CONTRACT 1725

**CIPP REHABILITATION OF THE
LOWER SAW MILL RUN INTERCEPTOR**

ADDENDUM NO. 3

Contract: 1725
CAD File Name: 1725_K_01.DGN
Date: 5/28/2020
Sheet: 3 OF 30

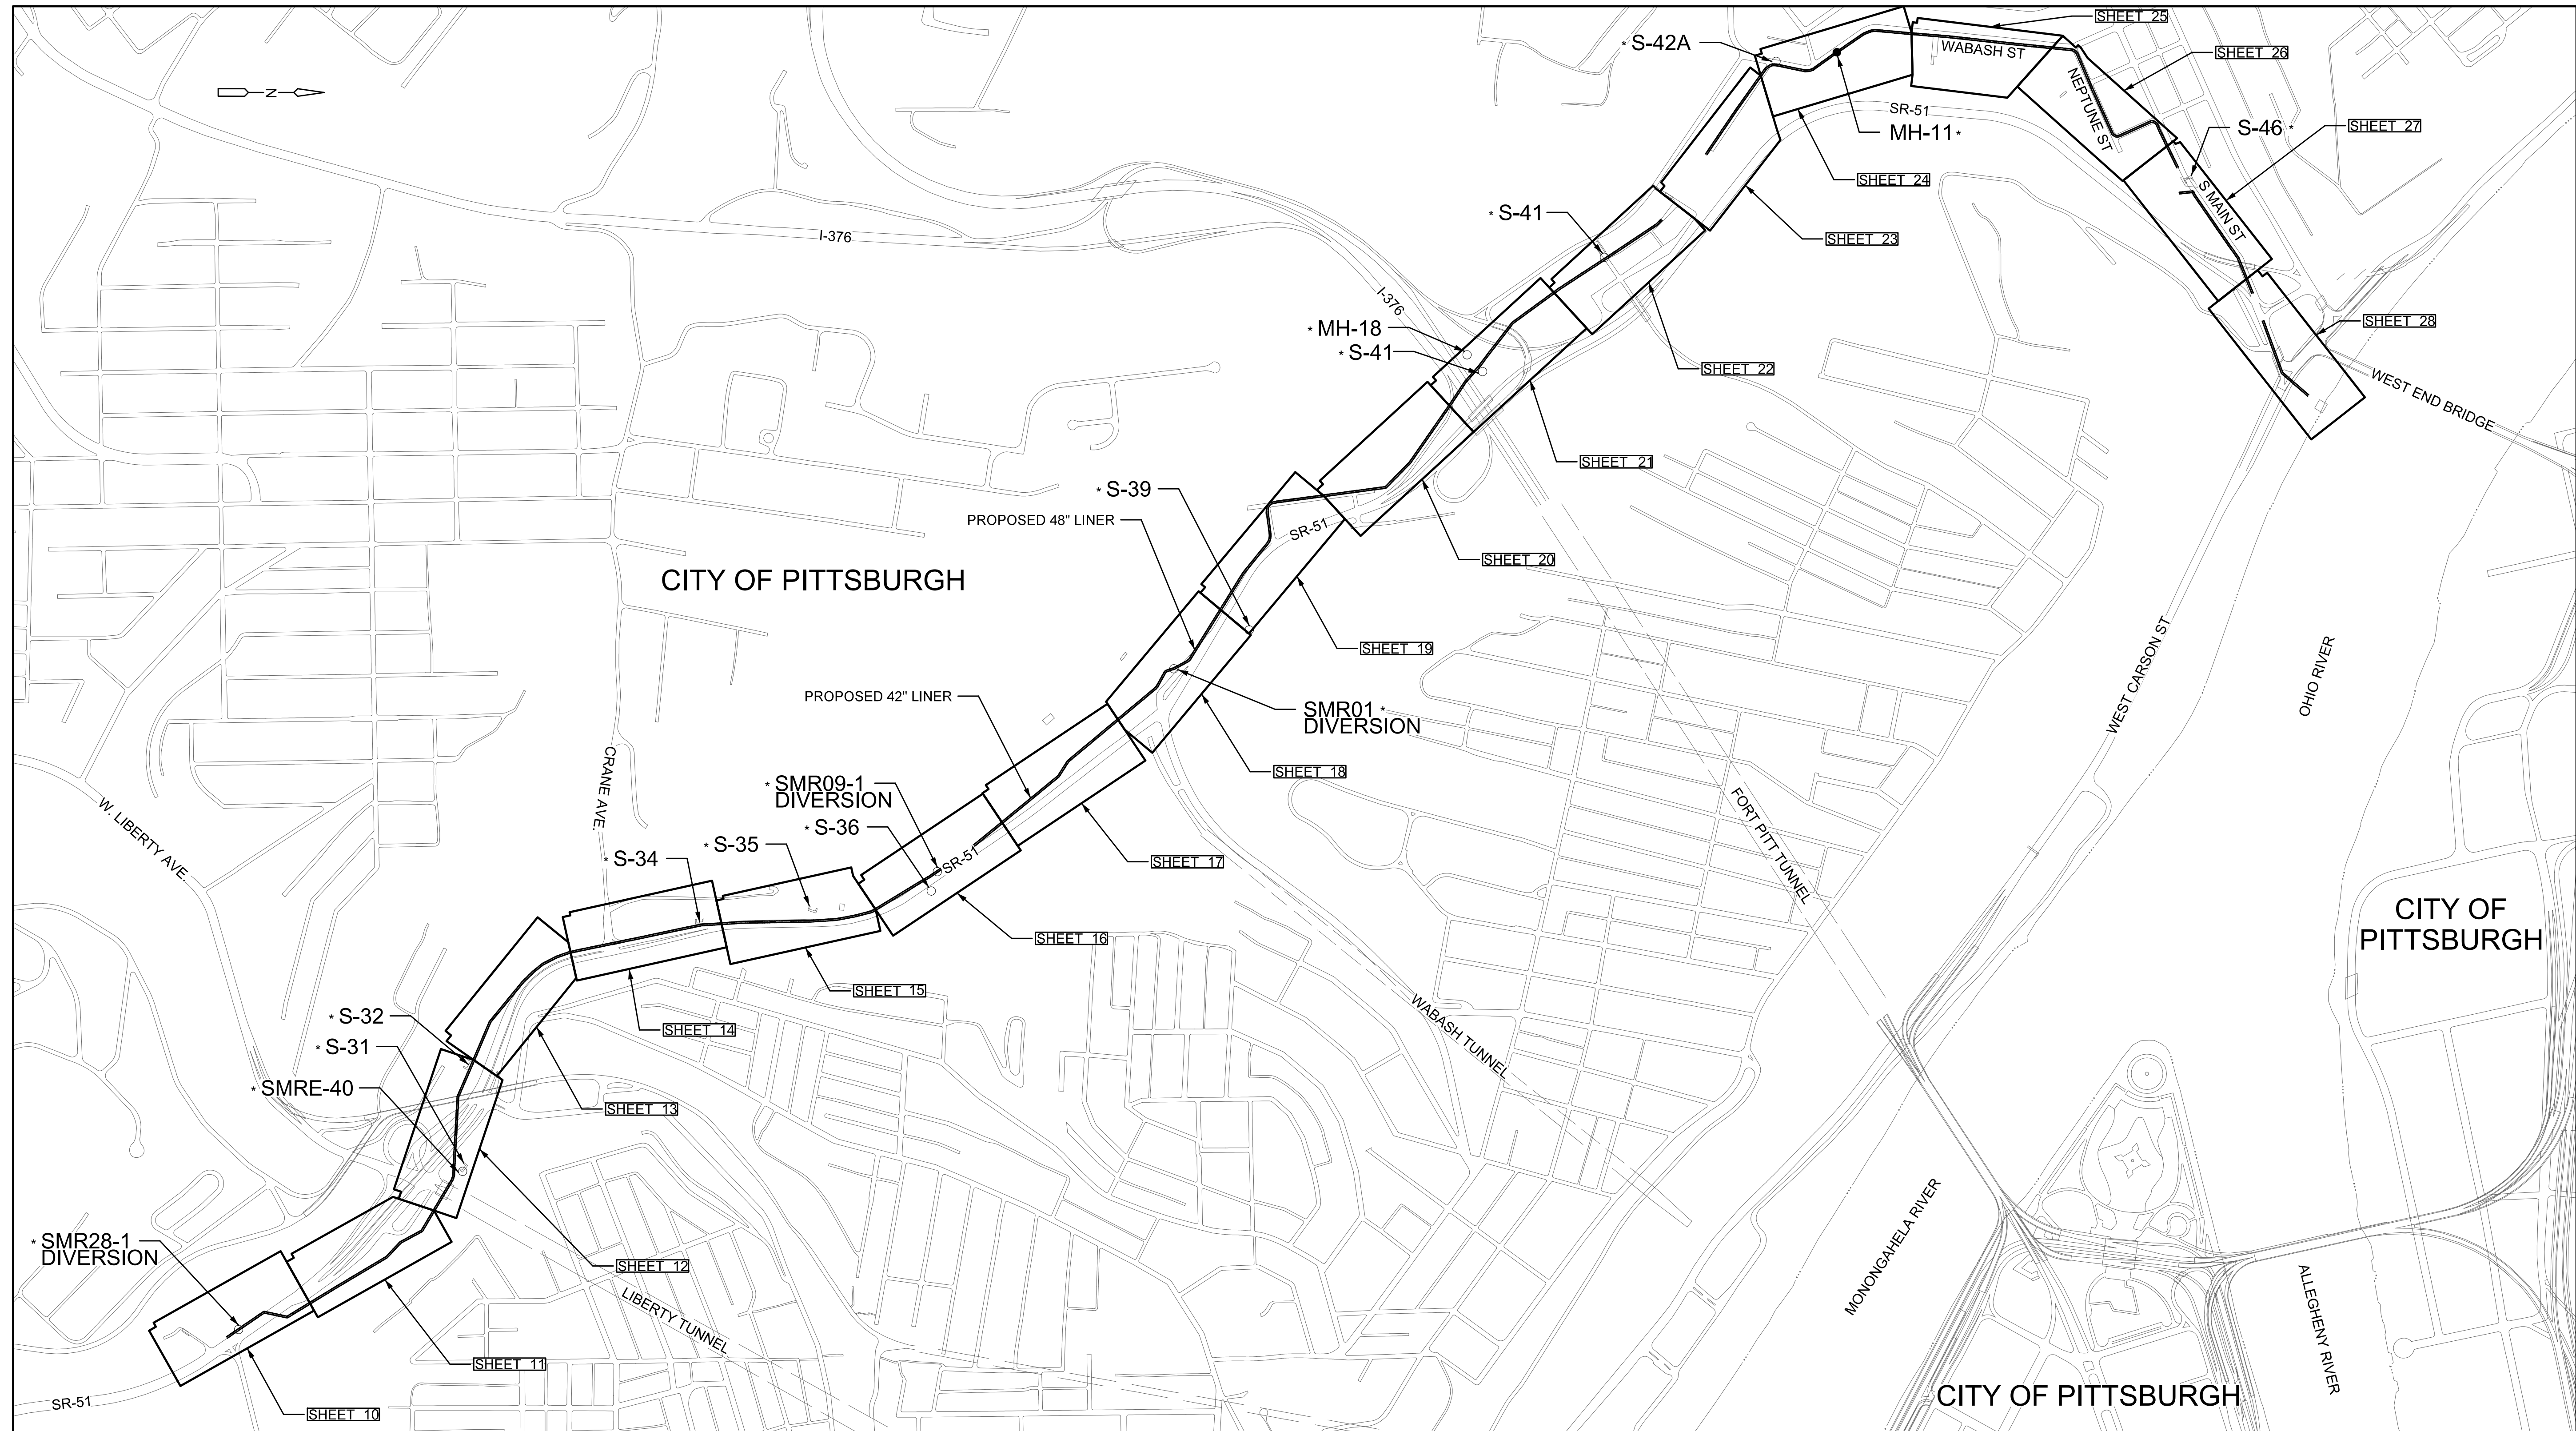
Sheet 3 of 30

See Revision No. 1 – added Points of Connection

Sheet 3 of 30 – KEY MAP was modified to show the locations of points of connection where flows previously included in Appendix B enter the interceptor system to further clarify how the system functions.

REV No.	DATE	REVISION DESCRIPTION	APPV
1	7/23/20	SHOW POINTS OF CONNECTION PER ADDENDUM NO. 3

PIPE AND MANHOLE REHABILITATION / GPS SCHEDULE

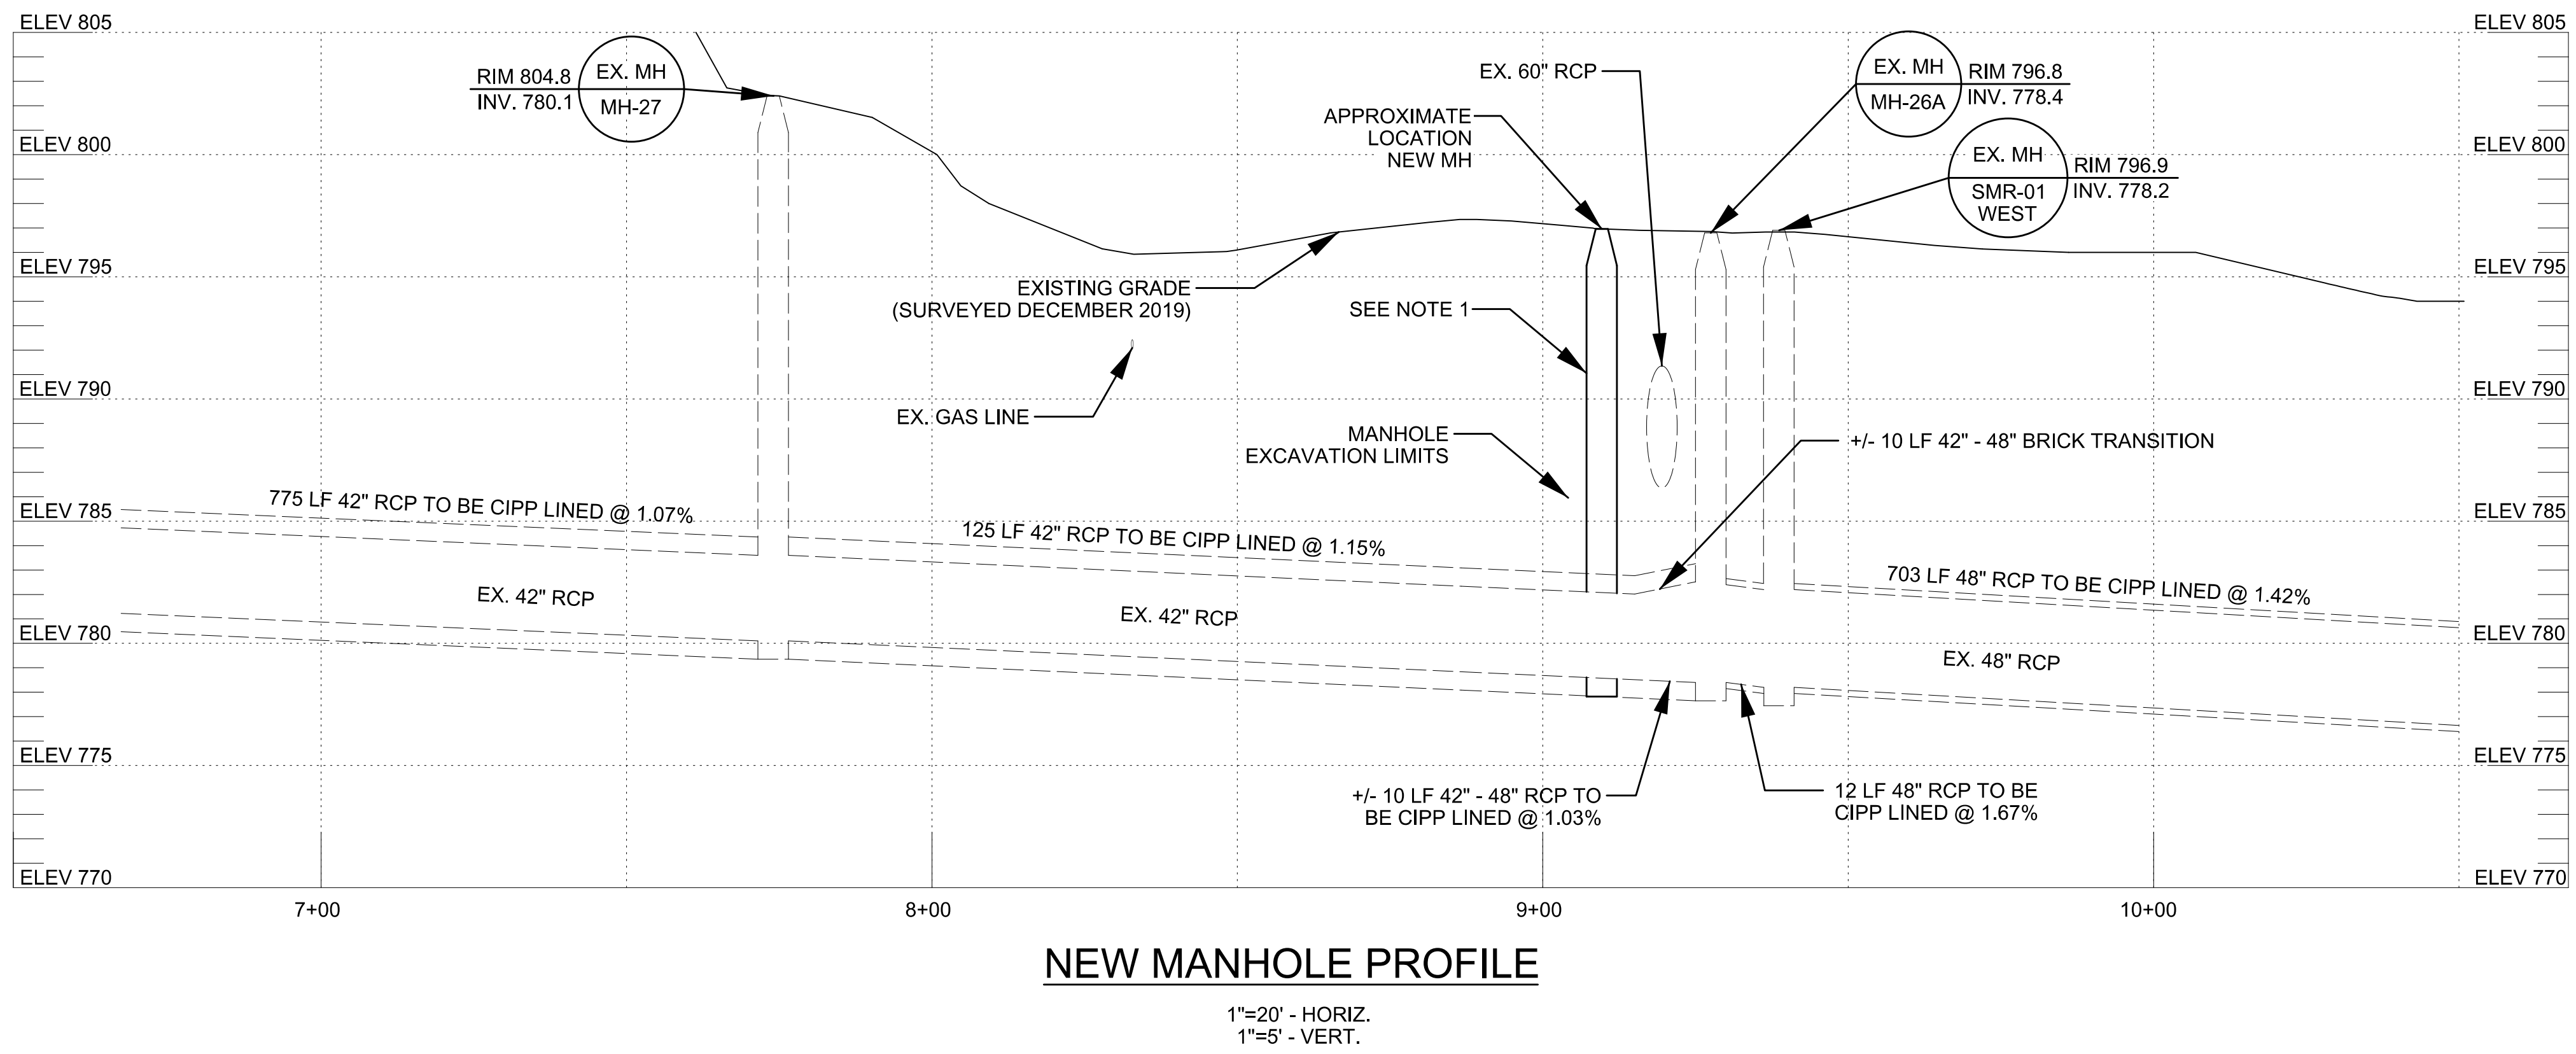
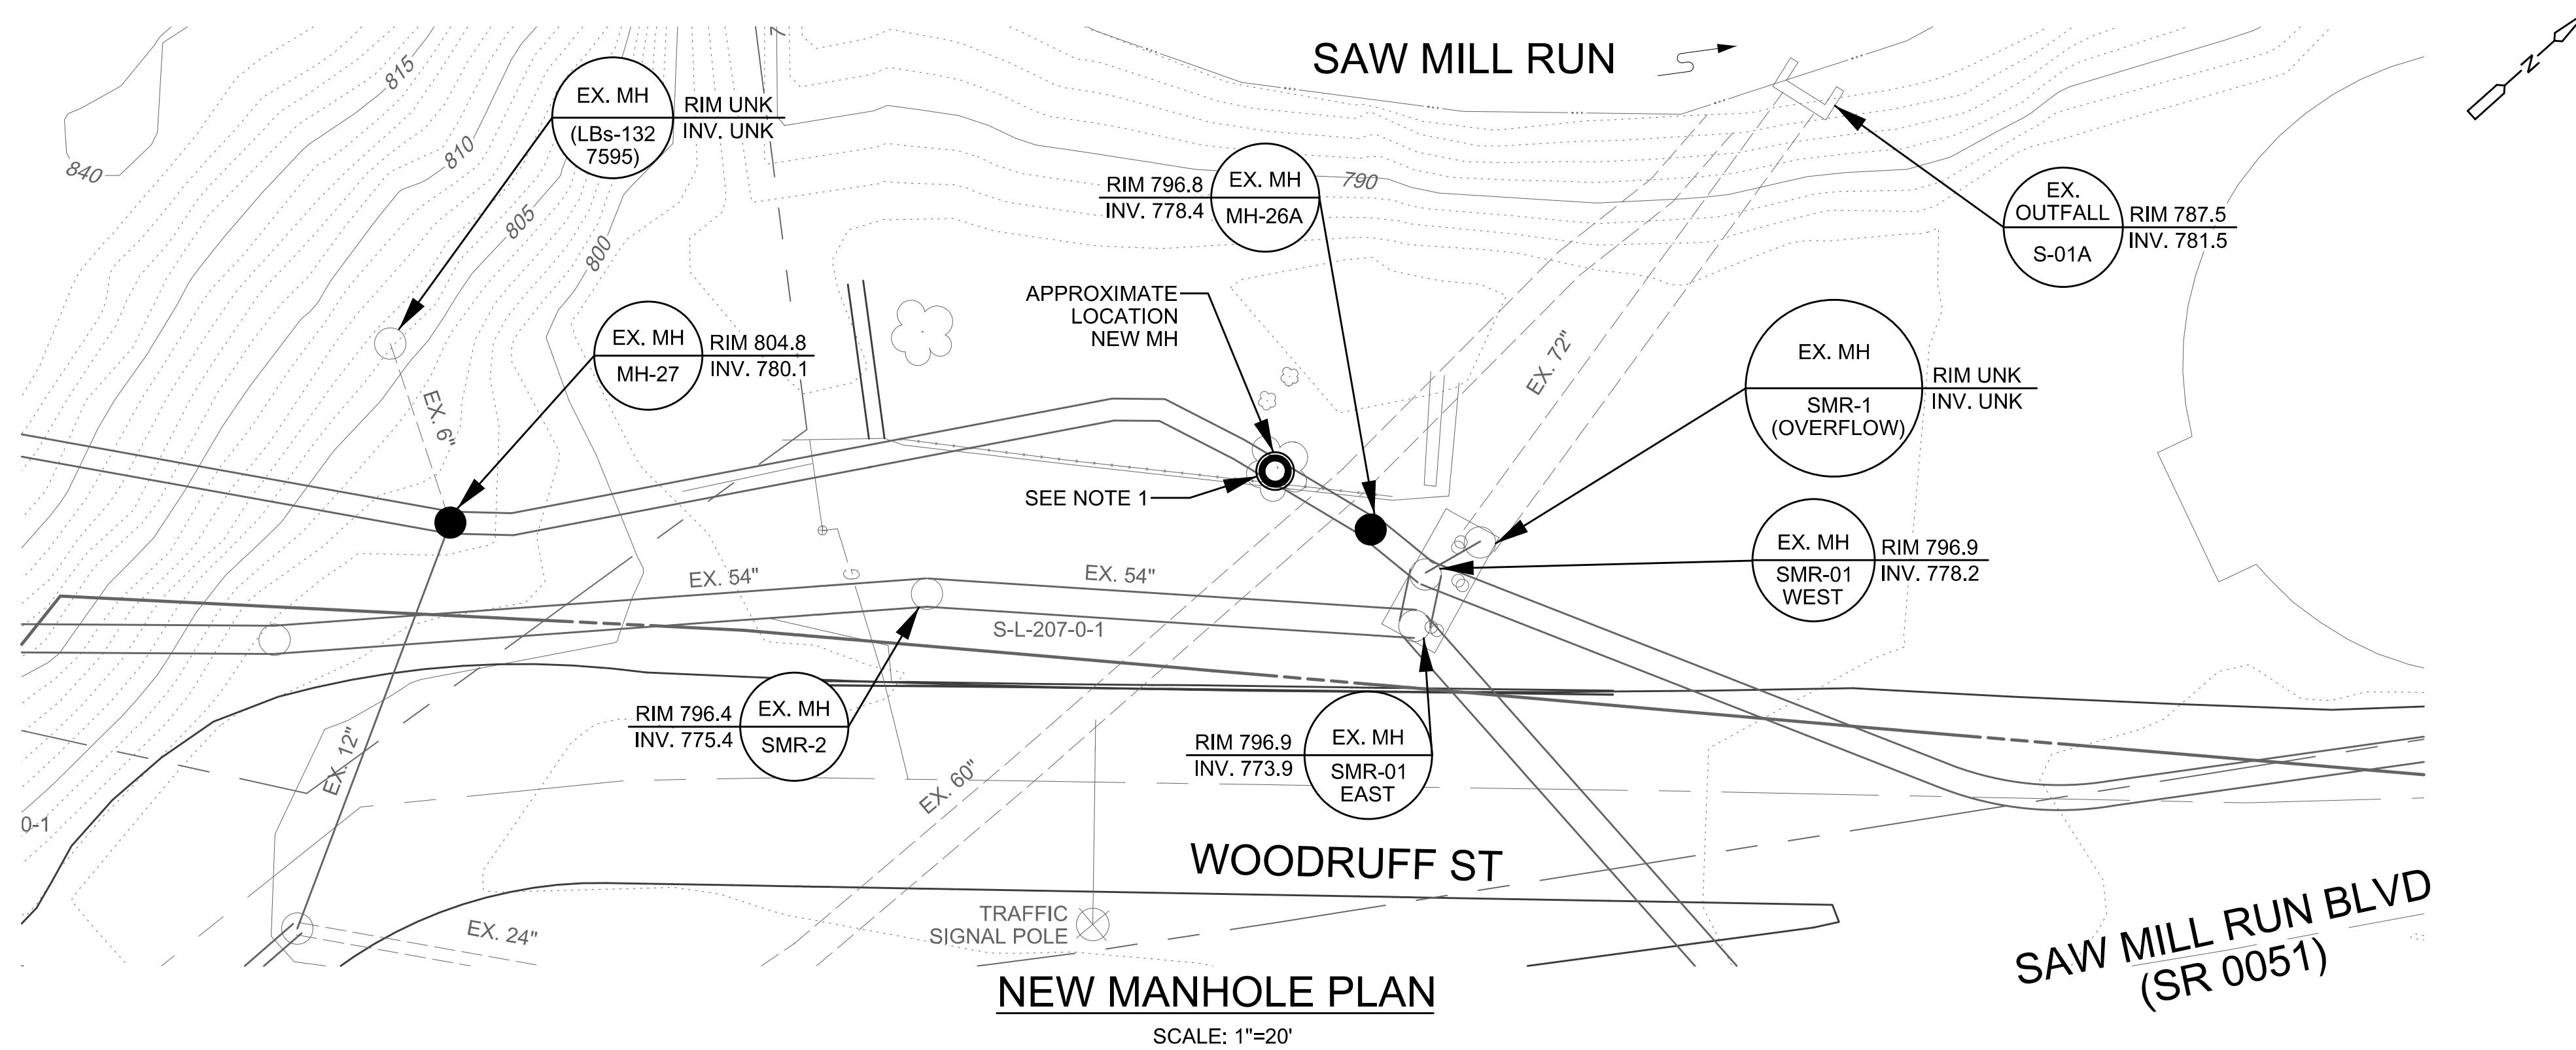
Sheets 8 and 9 of 30

Delete pipe upstream and downstream invert elevations and modify Note 3 to include adding upstream and downstream pipe invert elevations.

Designed by: D. McCONNELL	REVISION			APPV	 FINAL DESIGN			ARLETTA SCOTT WILLIAMS EXECUTIVE DIRECTOR, ALCOSAN 3300 PREBLE AVE. PITTSBURGH, PA 15233 (412) 766 - 4810 www.alcosan.org	ALLEGHENY COUNTY SANITARY AUTHORITY REGIONAL CONVEYANCE SYSTEM CIPP REHABILITATION OF THE LOWER SAW MILL RUN INTERCEPTOR 1725_MHTBL_01 PIPE AND MANHOLE REHABILITATION / GPS SCHEDULE	Contract: 1725 CAD File Name: 1725_MHTBL_01.DGN Date: 5/28/2020 Sheet: 8 OF 30
	Drawn by: N. KLEYA	REV No.	DATE							
Checked by: M. GRIFFIN	1	7/23/20	REMOVE INVERT ELEVATIONS PER ADDENDUM NO. 3.
